Road Safety Audit Report

Incorporating Stage 1 Completion of Preliminary Design;

Proposed Pedestrian, Cyclist and Emergency Access off Copper Lane Marden

Report Title:	Stage 1 Road Safety Audit
Date:	September 2024
Document reference and revision:	RSA-24-113-4
Prepared by:	Fenley Road Safety Limited
On behalf of the Overseeing Organisation:	Kent County Council
Design Organisation:	i-Transport
Project Sponsor:	B.Yond Homes

Item Location Plan

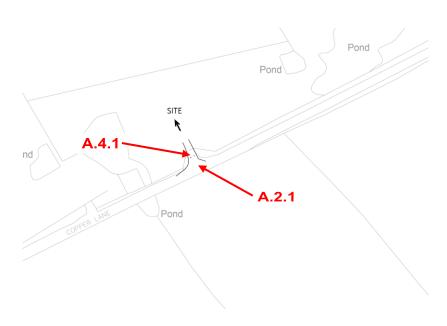
A.1	LOCAL ALIGNMENT			
	No Road Safety Concerns regarding LOCAL ALIGNMENT have been raised at this			
	stage.			
A.2	GENERAL			
A.2.2	PROBLEM			
Location:	Copper Lane			
Summary:	Vehicles are likely to continue to utilise the proposed access as a passing bay			
Acc Type:	Vehicle loss of control and to non-motorised user type collision

Copper Lane is a rural single carriageway lane that allows for one-way traffic only. A number of field accesses are present along the lane which as observed during the site visit, are utilised as passing places. The proposals include modifications to an existing field access to form a pedestrian, cyclist and emergency access associated with a proposed development of circa 120 dwellings. The scheme drawing illustrates that visibility to / from the proposed access is achievable in accordance with observed speeds, albeit to the centre of the carriageway to the west and a 0.5 metre offset to the east, and therefore non-motorised users and approaching motorists will become aware of one another. No details of the proposed surface have been provided at this stage, however, it would appear that the existing geometric parameters of the access are to be amended. This results in a reduction in the area that can be utilised for vehicles to pass. The Audit Team have concerns that vehicular traffic will attempt to utilise the access as a passing place. A vehicle attempting to utilise a passing place which does not benefit from adequate geometry, is likely to encroach outside the carriageway which may lead to loss of control as well as vehicle to non-motorised user type collisions.

It is recommended that the geometric parameters of the access are retained to allow for use as a passing bay.

A.3	JUNCTIONS					
	No Road Safety Concerns regarding JUNCTIONS have been raised at this stage.					
A.4	WALKING, CYCLING AND HORSE RIDING					
A.4.1	PROBLEM					
Location:	Albion Road and Copper Lane					
Summary:	Pedestrians could step into the live carriageway without warning					
Acc Type:	Vehicle to pedestrian type collision

Copper Lane is rural in nature and does not benefit from footways but is subject to a 30mph speed limit. The proposals include the provision of a pedestrian, cyclist and emergency access off Copper Lane at the location of an existing field gate. The proposed pedestrian, cyclist and emergency access will allow level access to the carriageway, however, the Audit Team have concerns that no measures are provided to warn pedestrians of the change in characteristics of the route. Pedestrians and cyclists stepping from a shared footway cycleway onto alive carriageway, could unknowingly step into the path of an oncoming vehicle which may lead to a vehicle to non-motorised user collisions.

It is recommended that measures are provided to highlight the change in characteristics of the route.

Agreed – The existing geometry within the adopted highway will be retained with the proposed pedestrian / cyclist and emergency access taken off the back edge of the informal passing bay as show in drawing ITB15098-GA-057A.

Confirmation that the existing informal passing bay will be retained, addresses the road safety concern at this stage.

Agreed – Corduroy paving will be provided along with signage to highlight the transition from the footway / footway cycleway link to the shared surface rural carriageway.

Confirmation that hazard warning corduroy paving and signage will be provided, addresses the road safety concern at this stage.
